**COUNTY OF SAN MATEO
PLANNING AND BUILDING DEPARTMENT**

SUBJECT: EXECUTIVE SUMMARY: Consideration of Design Review Permit and a Grading Permit, to allow construction of a new 2,394 sq. ft. single-family residence (1,932 sq. ft. residence with an attached 441 sq. ft. garage), and associated grading in the amount of 668 cubic yards, on a 7,623 sq. ft. legal parcel located on Cordilleras Road in the unincorporated Emerald Lake Hills area of the County. Four significant trees are proposed to be removed. (Appeal of the approval by the Community Development Director.)

County File Number: PLN 2014-00409 (Zmay)

SUBJECT: Consideration of a Design Review Permit and a Grading Permit, pursuant to Section 6565.3 of the San Mateo County Zoning Regulations and Section 8602 of San Mateo County Ordinance Code, respectively, to allow construction of a new 2,394 sq. ft. single-family residence (1,932 sq. ft. residence with an attached 441 sq. ft. garage) on a 7,623 sq. ft. legal parcel. Four significant trees are proposed to be removed. The project also requires a grading permit for the amount of 668 cubic yards of grading. (Appeal of the approval by the Community Development Director).

EXHIBIT TWO
DESIGN Rvw
LETTER-INGRAM
PLN2014-00409

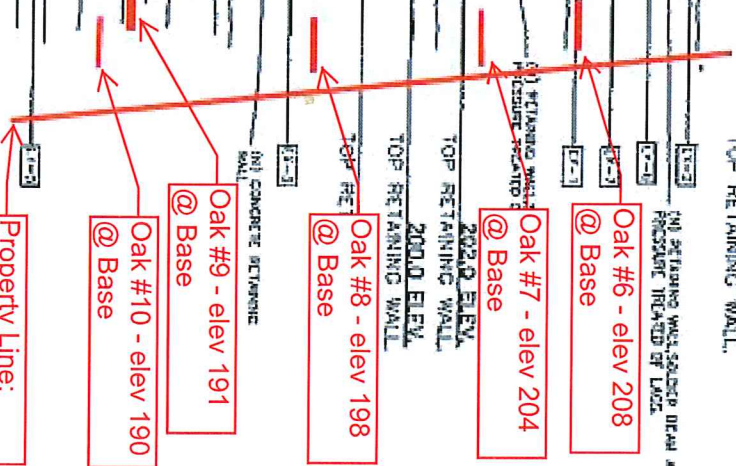
As shown on Exhibits 2 and 3 prepared by my client and attached hereto, the excavation and drainage plans propose retaining walls and drainage pipes running parallel to the retaining walls, within just 12-30 inches of each trunk of the remaining five significant indigenous trees (which trees are not even shown on the drainage plans!). This is contrary to best practices recommended by the International Society of Arboriculture and required by many nearby cities including the City of San Mateo, Portola Valley, Palo Alto, and Woodside to name a few, which prohibit surface and grading disturbance within the drip line of a tree canopy.

Exhibit A: *Marked-up Sheets T1 & A6*

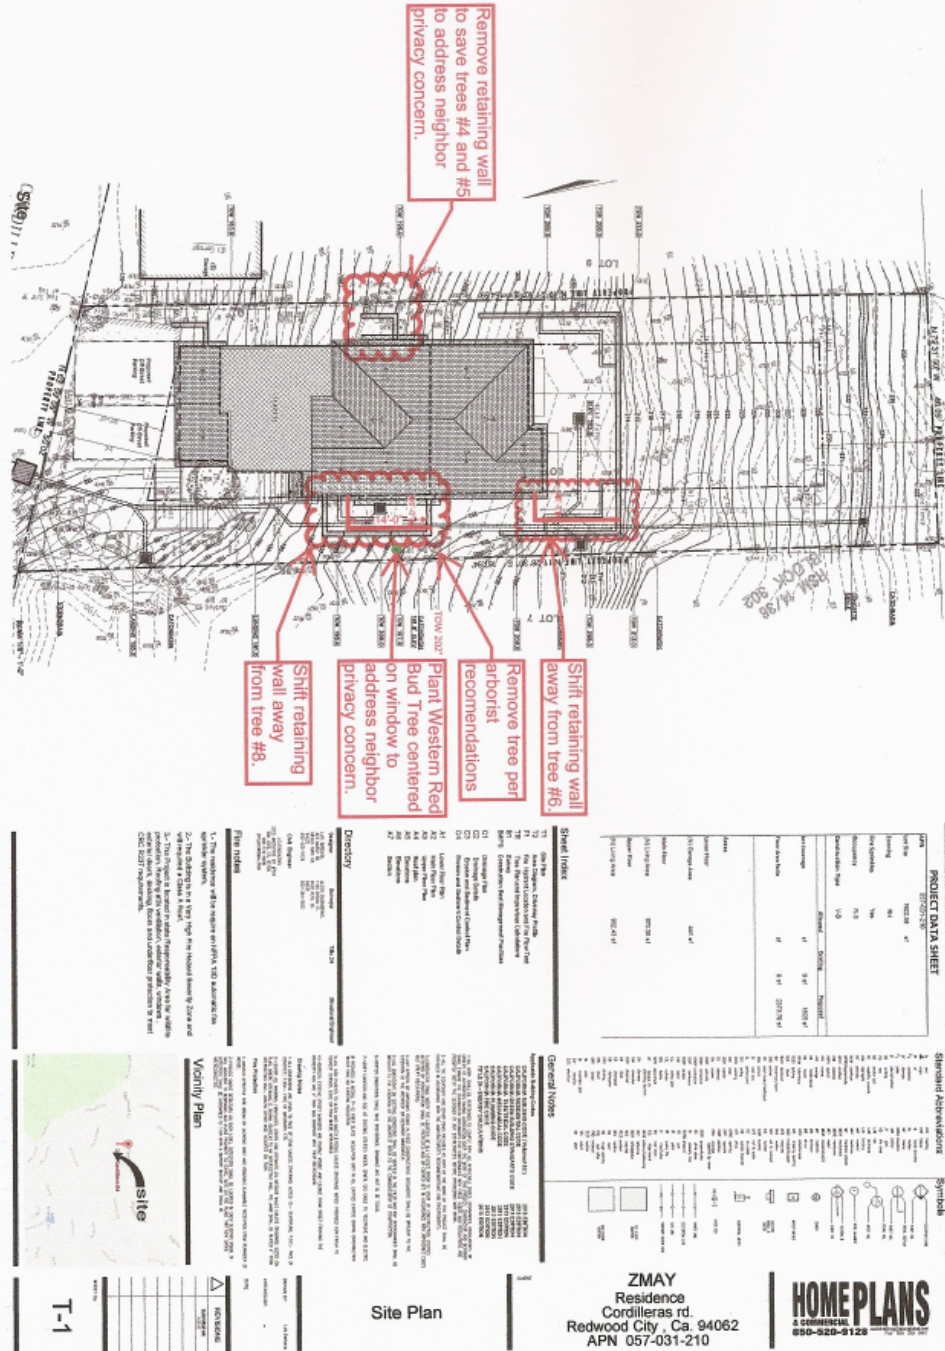
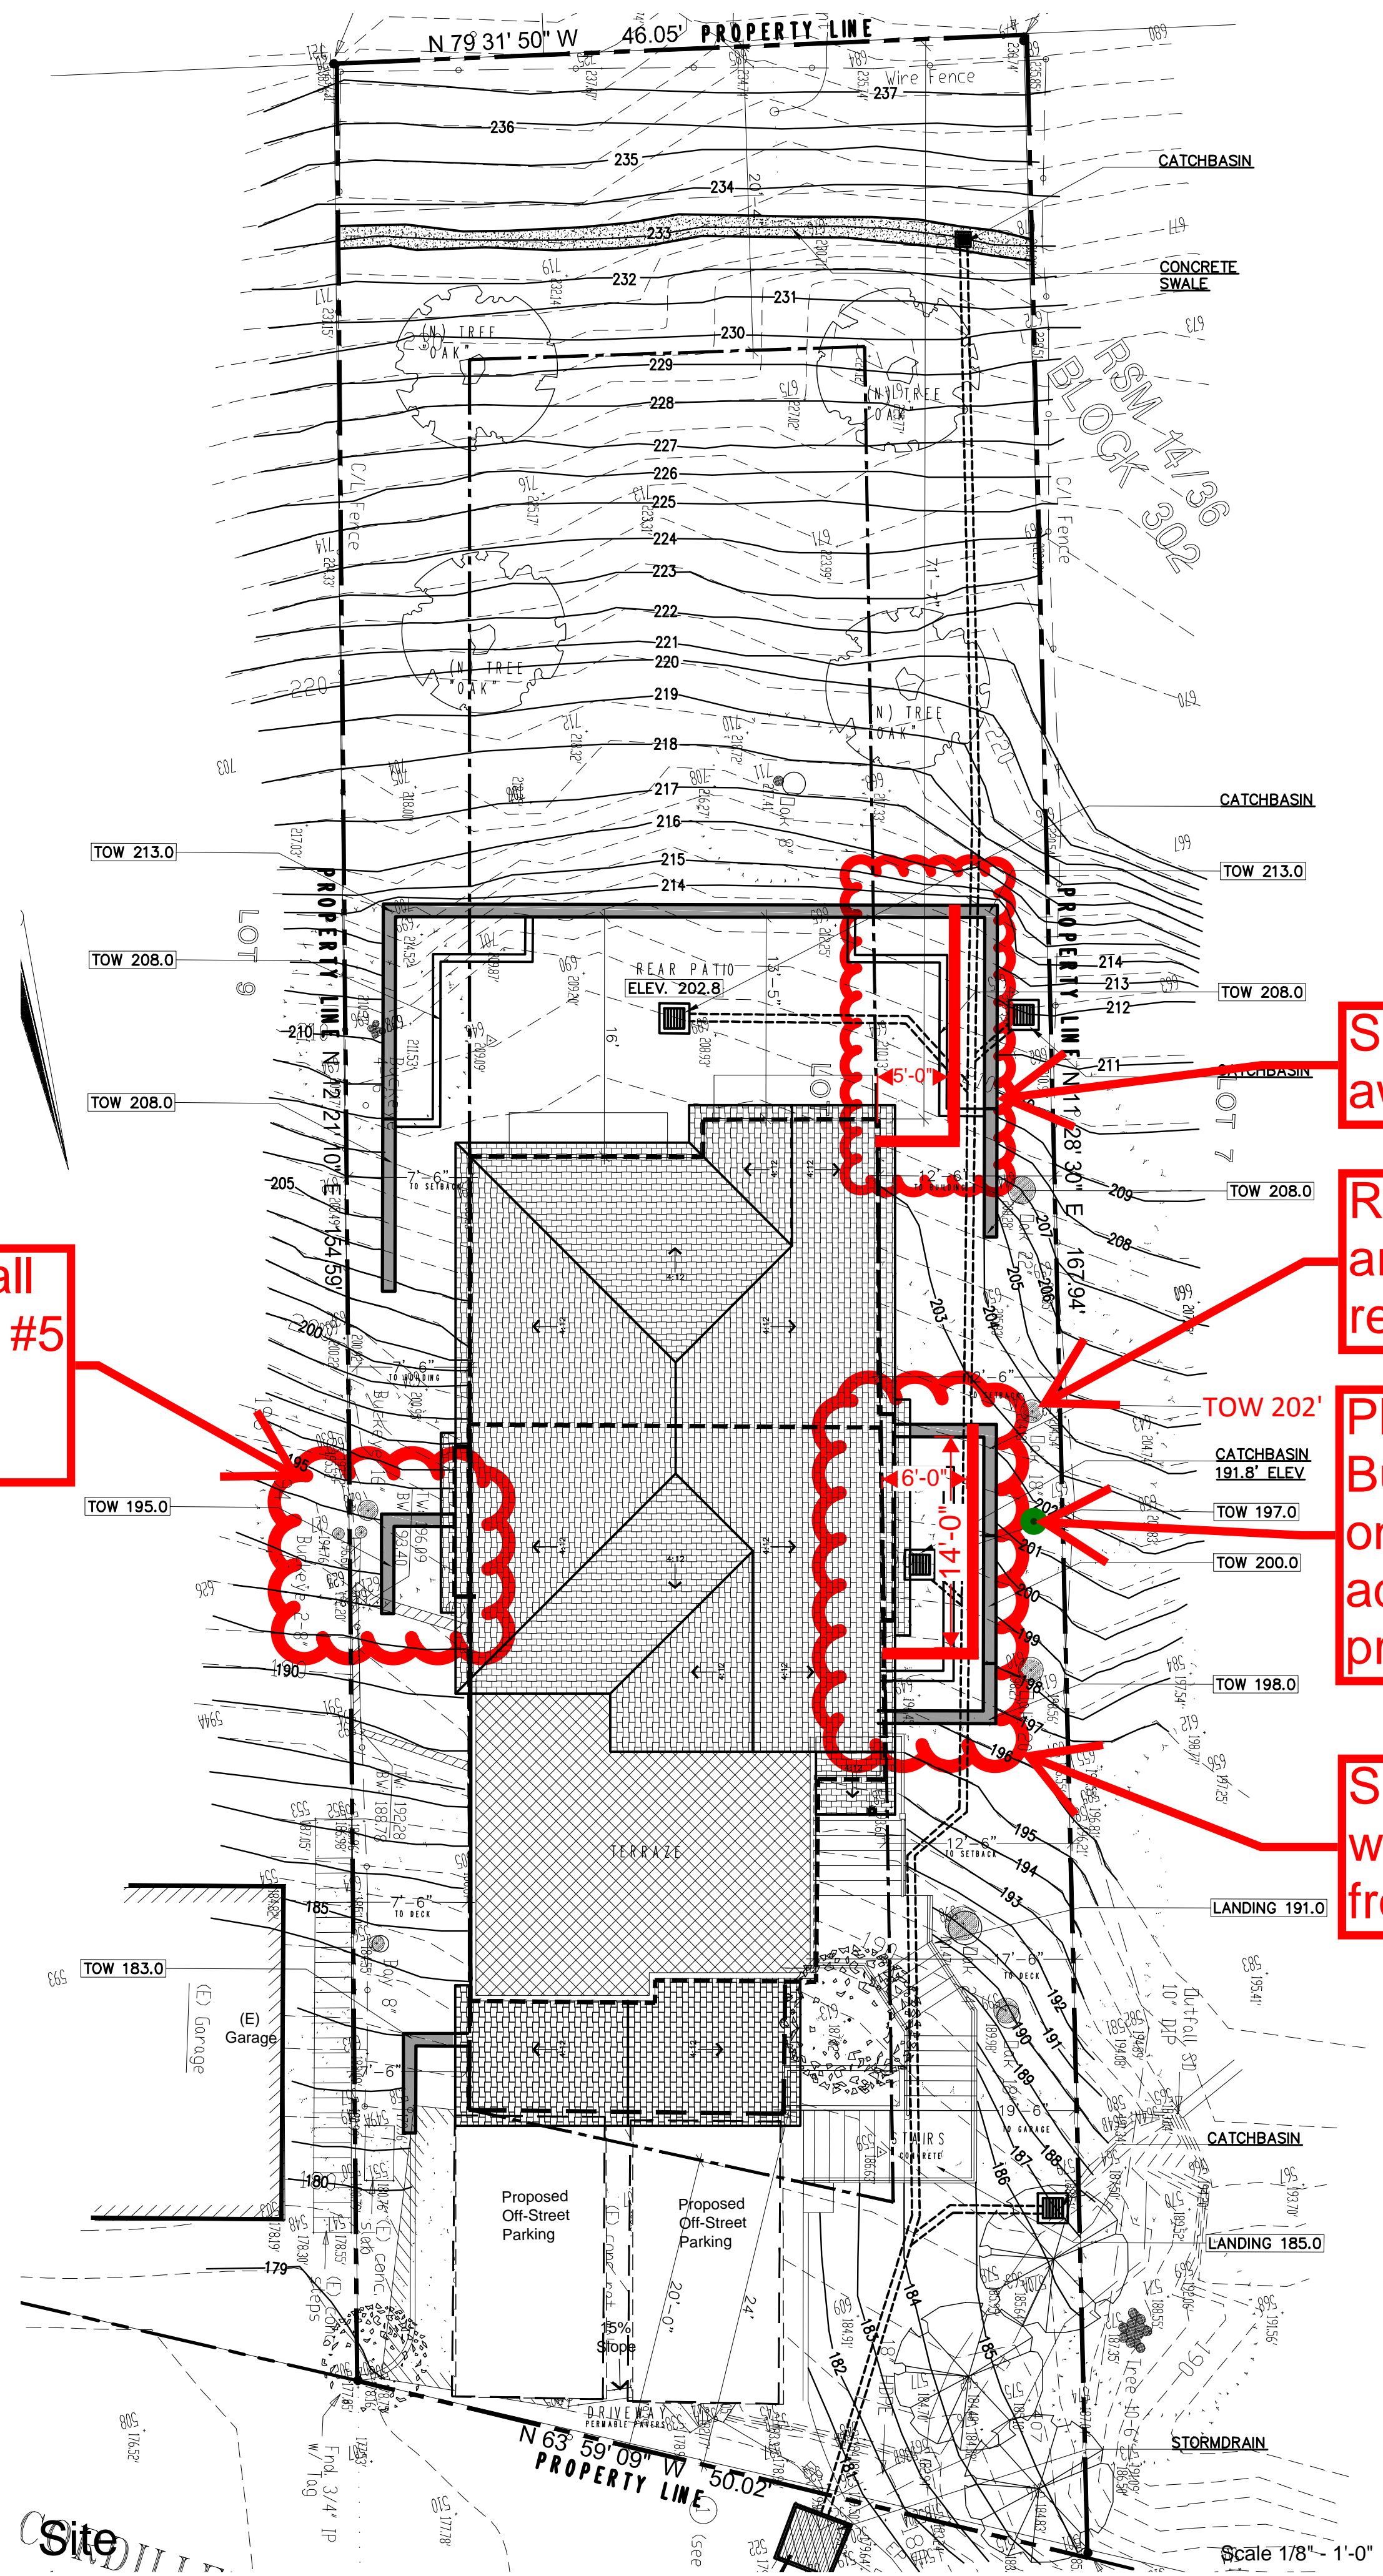
The applicant submitted a second supplemental arborist report from Kiely Arborist Services, dated August 11, 2014, which includes a detailed tree protection plan with measures for each tree located within the construction zone. To address the appellants' concern with the proximity of retaining walls to Trees #6 and #8, the applicant states that the retaining walls will be shifted to better help preserve the trees. Plans show a 2-ft. shift for the wall near Tree #6 and a 1-ft. shift for Tree #8.

Elevations

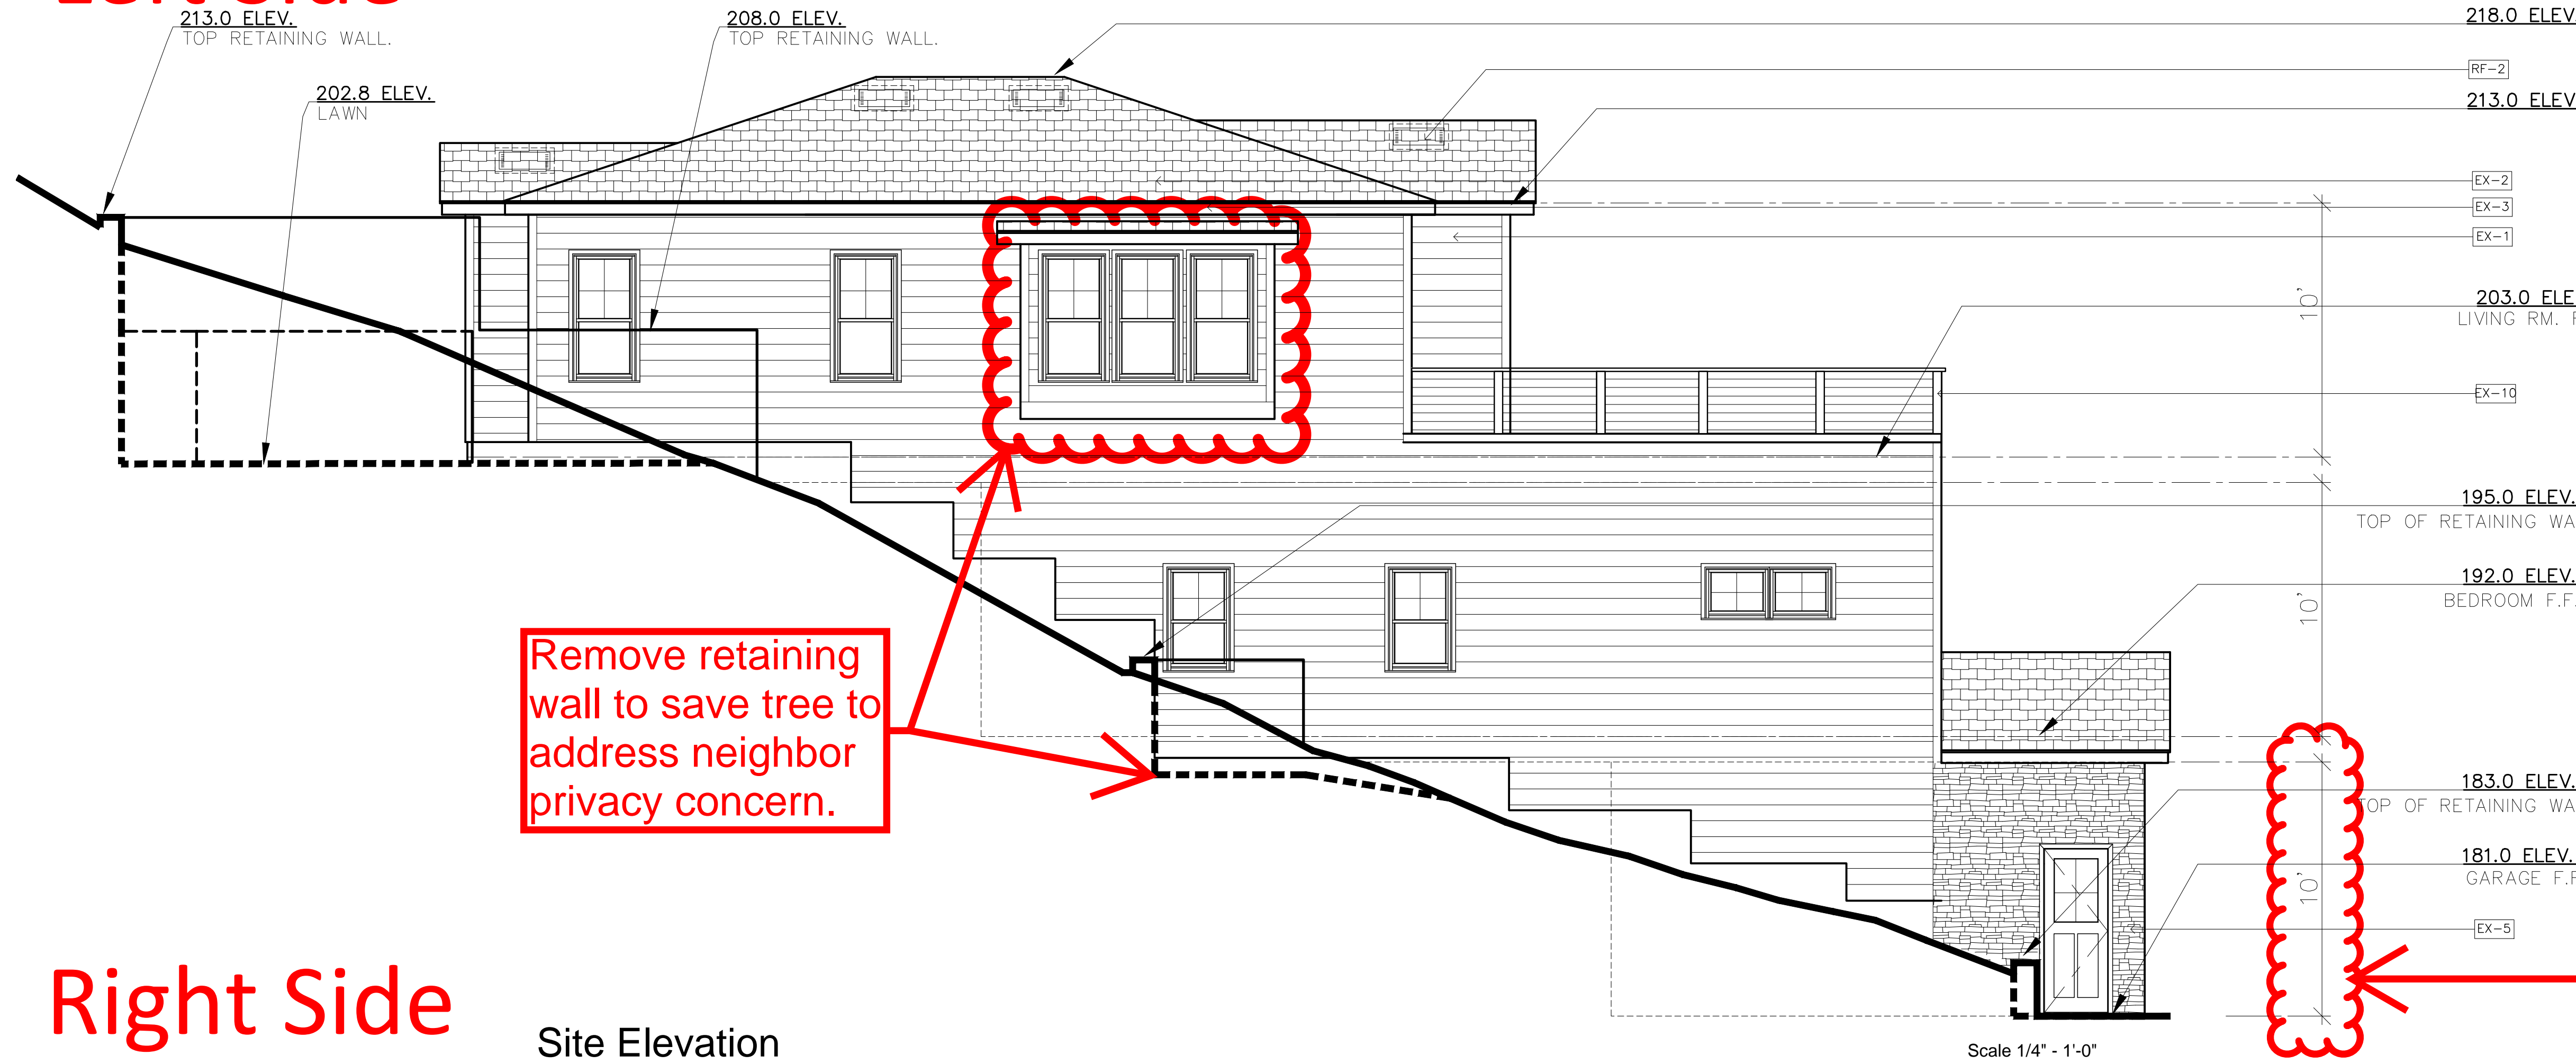
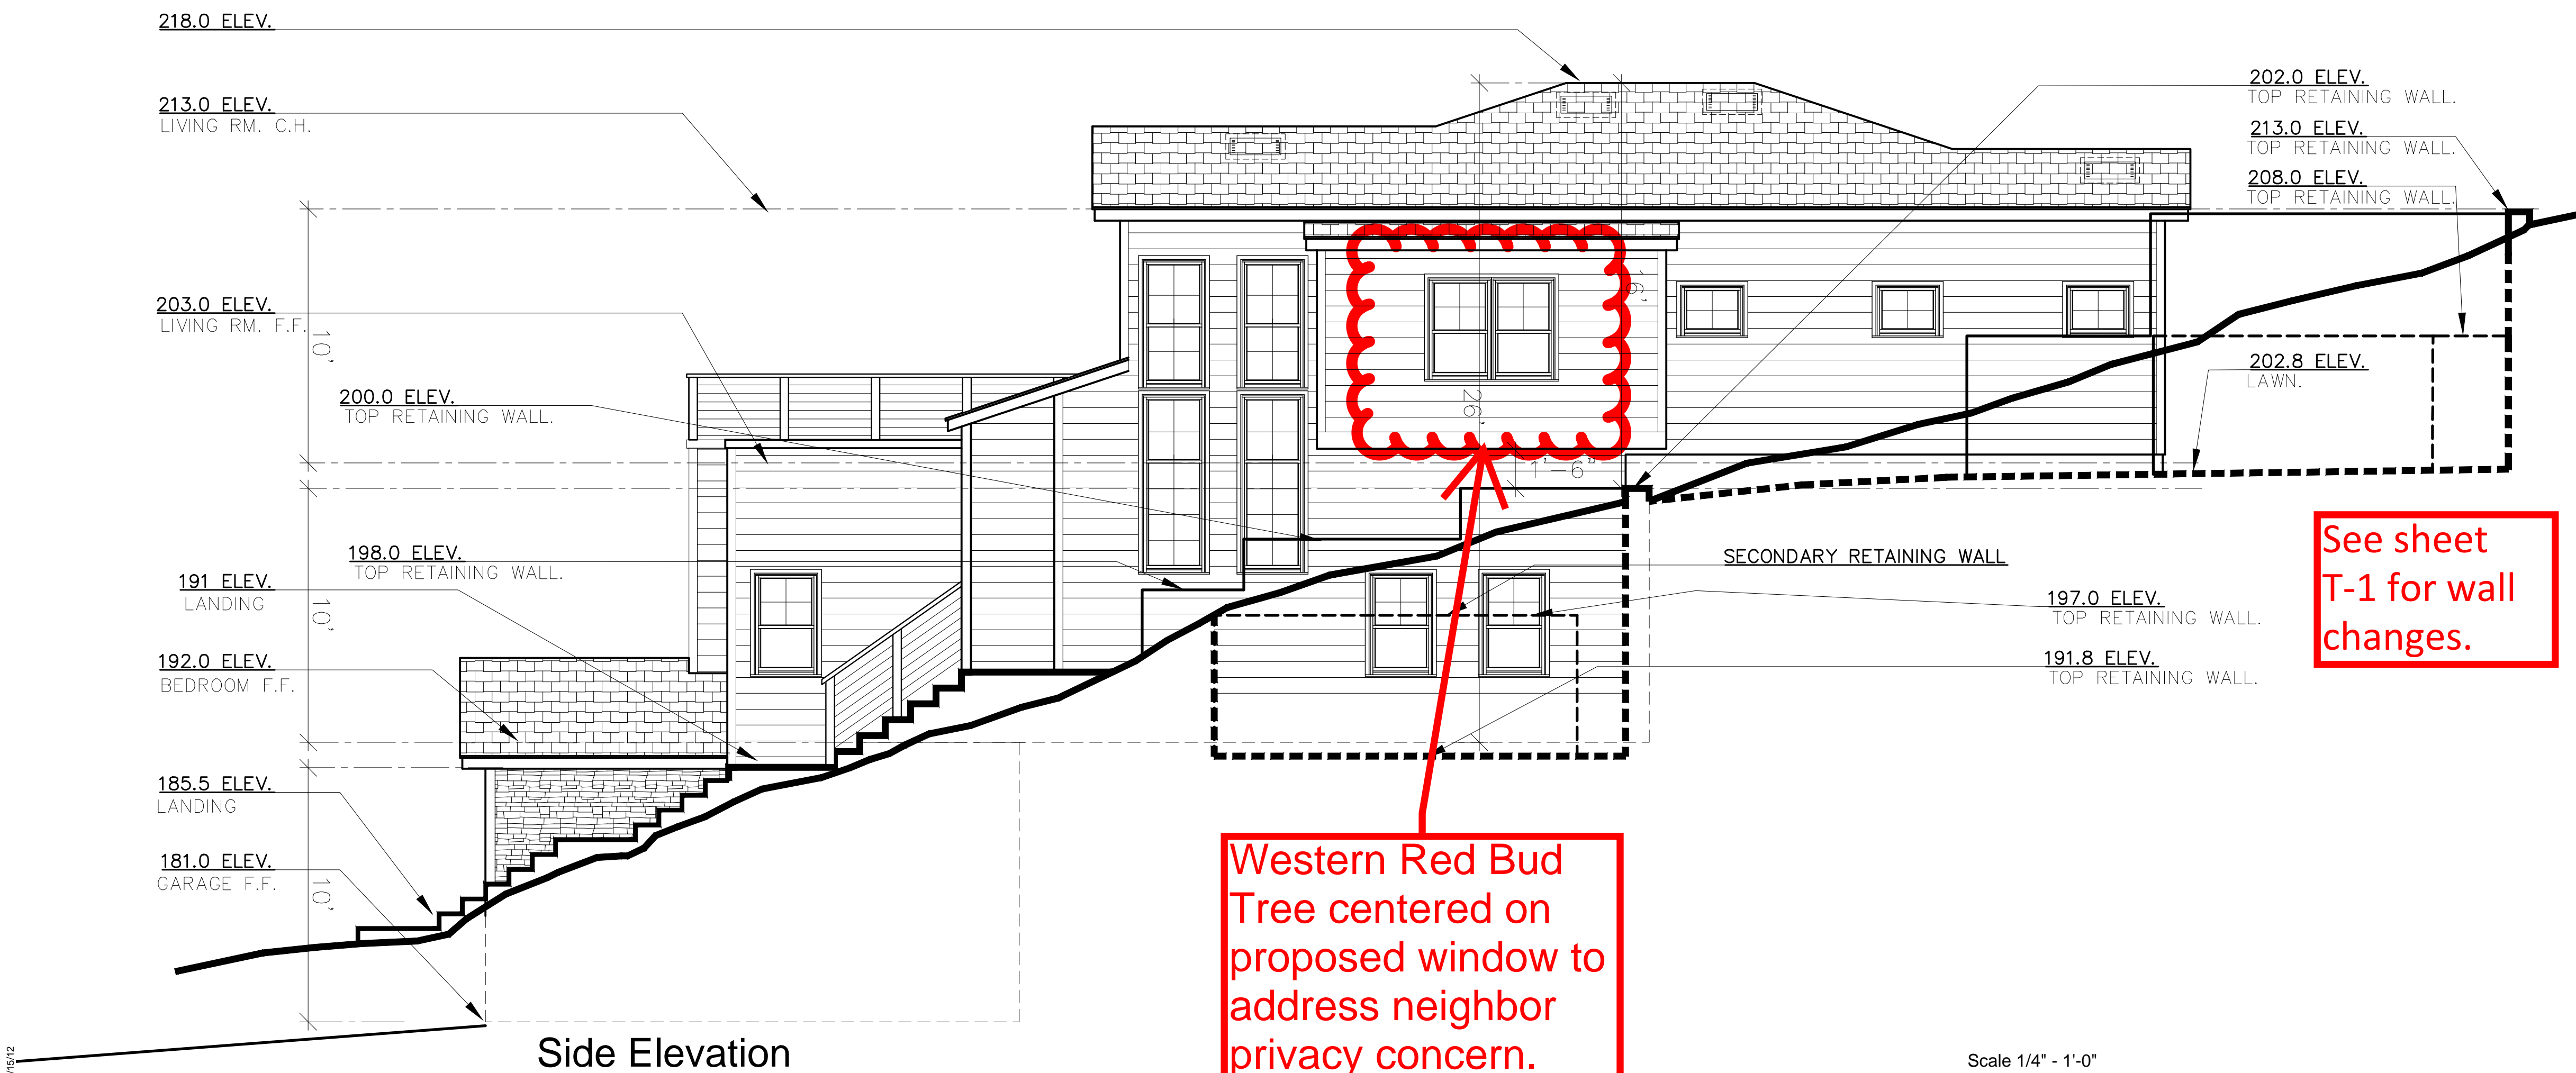
Remove retaining wall to save tree to address neighbor privacy concern.

The applicant has stated that to address the Thompson’s concerns of privacy, Trees #4 and #5 will be preserved by removing a retaining wall. The trees will provide a natural privacy screen between the residences. To address the Ingram’s concerns about privacy, the applicant will plant a red bud tree in front of the kitchen window. In addition, the finished floor elevation of the proposed home will be lowered by one foot.
